MC 09-01

MODEL: 2008 and 2009 Concours™ 14 (ZG1400A8F/L, B8F/L, A9F/L, B9F/L)

TITLE: BRAKE PEDAL COVER INSTALLATION

RECALL

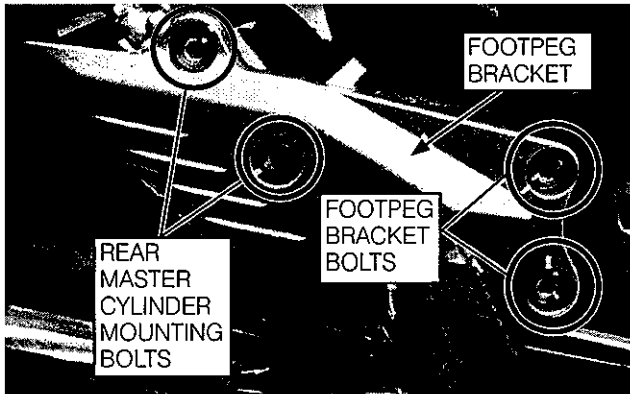
- Remove the right footpeg bracket bolts and rear master cylinder mounting bolts.

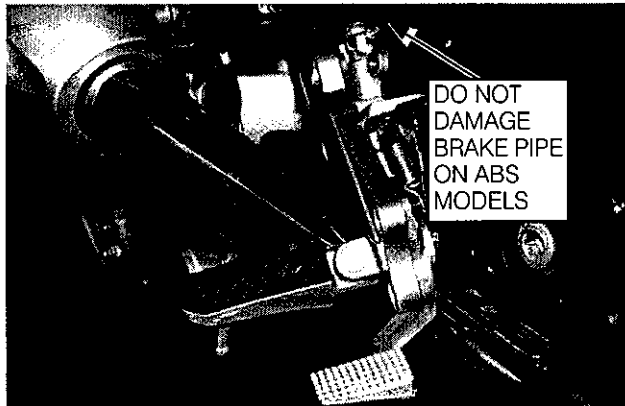
- o On ABS models, take care not to damage the brake pipe when installing the brake pedal cover.
- Rotate brake pedal and bracket away from frame as shown.

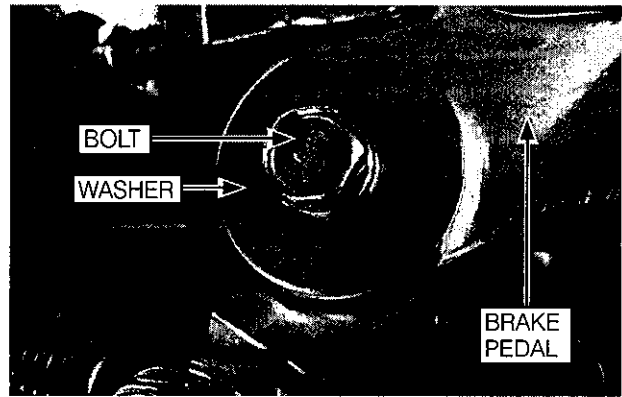
- Remove and discard the brake pedal pivot bolt and washer.

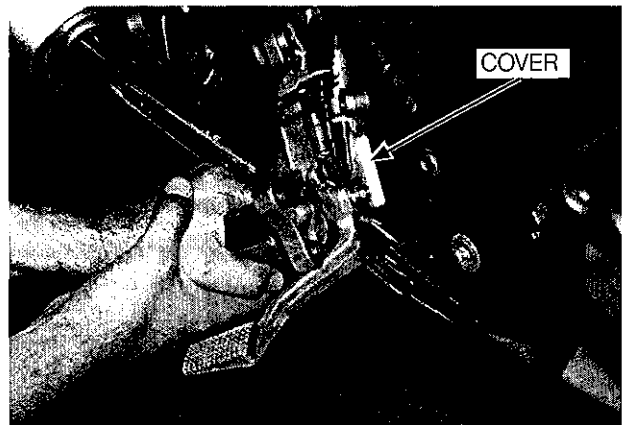
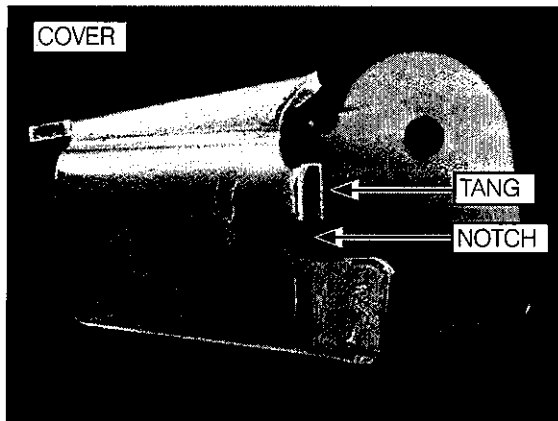
- Place the brake pedal cover into position as shown in the photographs below.

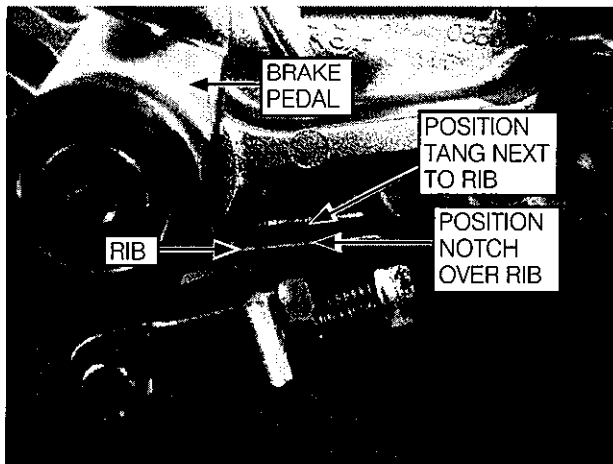
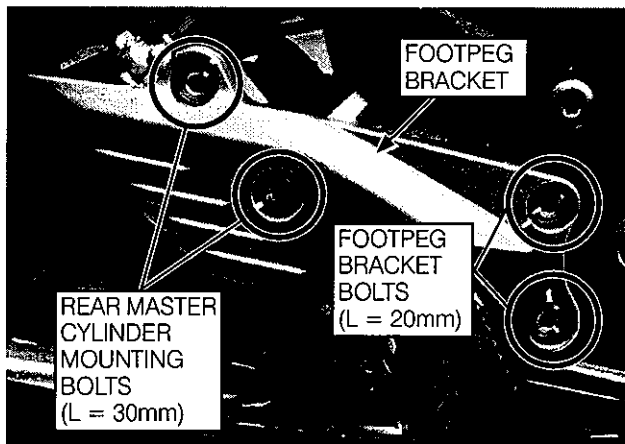
- When installed correctly, the tang and notch of the cover should be positioned against the footpeg bracket as shown below.

- Install the right footpeg bracket and rear master cylinder and tighten the bolts to 25 N-m (2.5 kgf-m, 18 ft-lb).

Repair Verification

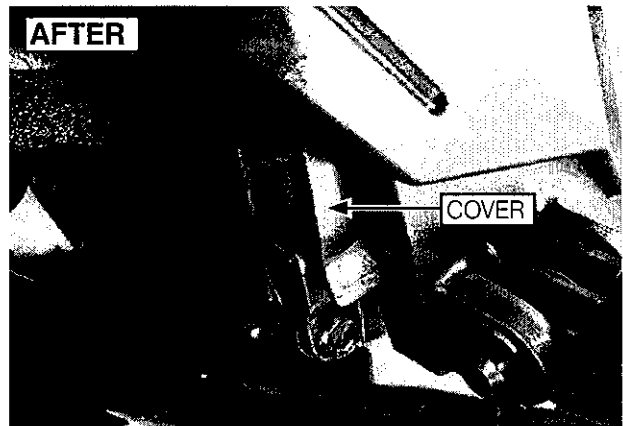
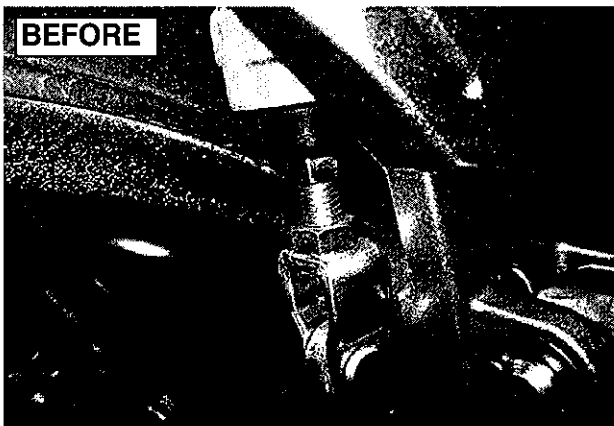
The brake pedal cover will serve as repair verification.
